# CrossRiverRail

## Environmental Impact Statement – Supplementary Report

**Environmental Impact Statement –  
Supplementary Report**

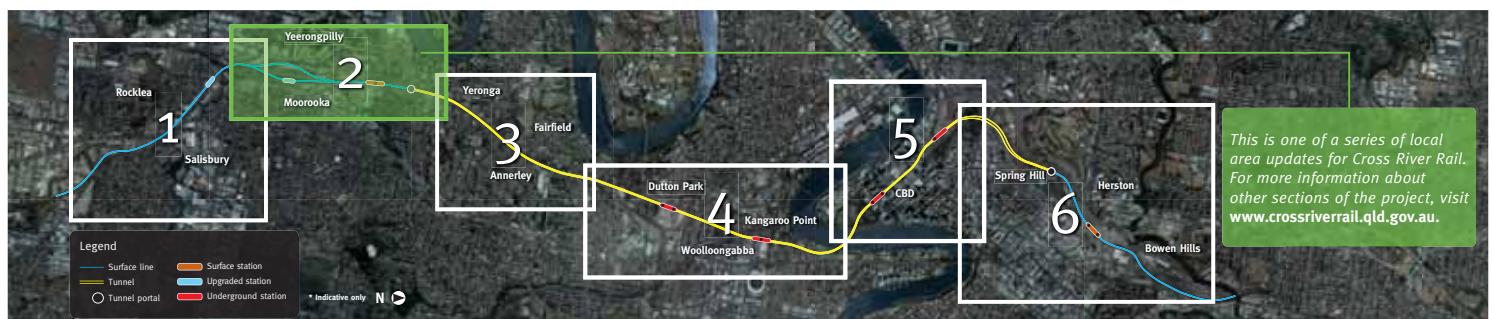
Design changes in the south now incorporate floodgates into the southern tunnel portal structure, meaning a separate building at Yeronga is no longer required.

The floodgates, which could be activated remotely or on-site, are sealed to ensure water cannot penetrate through to the tunnels.

CRR-BGO-W-5000 (Rev C)

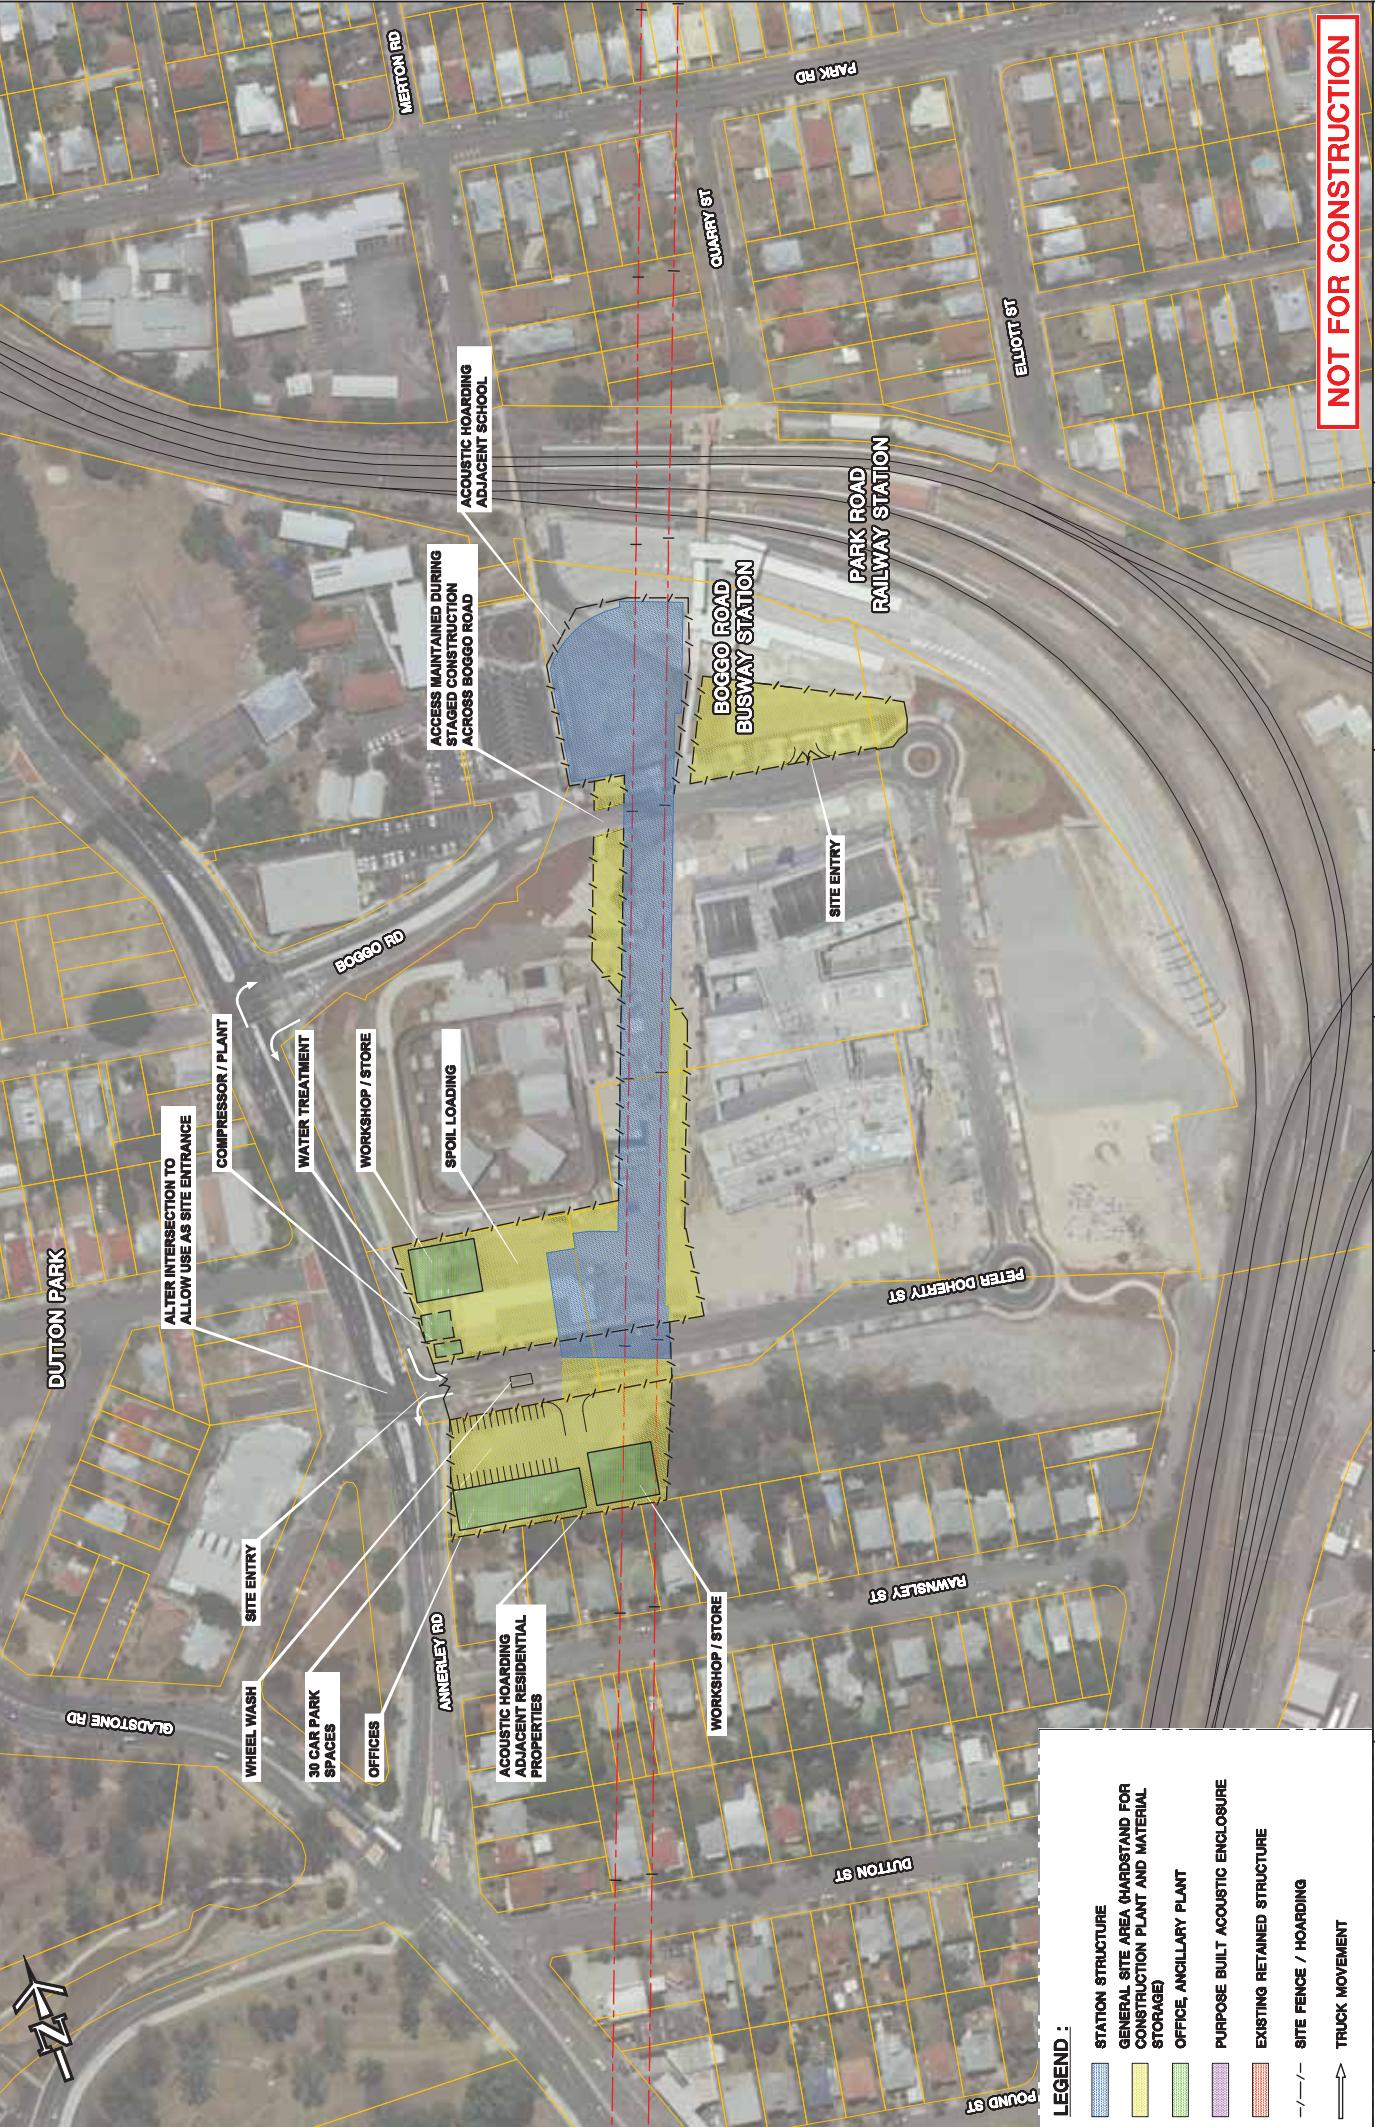
A refinement has been made to the location of a section of the Boggo Road worksite located at the intersection of Peter Doherty Street and Annerley Road in response to a submission about the future development of the southern portion of the worksite.

Refinements are also proposed to the remaining portion of the construction worksite on the northern side of Peter Doherty Street, to provide site access from Annerley Road via Peter Doherty Street. This would allow Peter Doherty Street to be reopened once the station roof has been constructed for the southern portion of the underground station.

The revised worksite arrangement, including the alternate worksite, is shown in **Appendix C**, along with the worksite arrangement identified in the EIS, Volume 2 – Reference Design Drawings.

The alternative worksite would be located near to the site of the planned Leukemia Foundation accommodation development, which is proposed to be completed in early 2012. This alternative worksite would include site offices and hardstand for workforce car parking, construction plant and materials storage. No other activities are proposed on this alternative worksite. There would be no exposed earth on this worksite, once established.
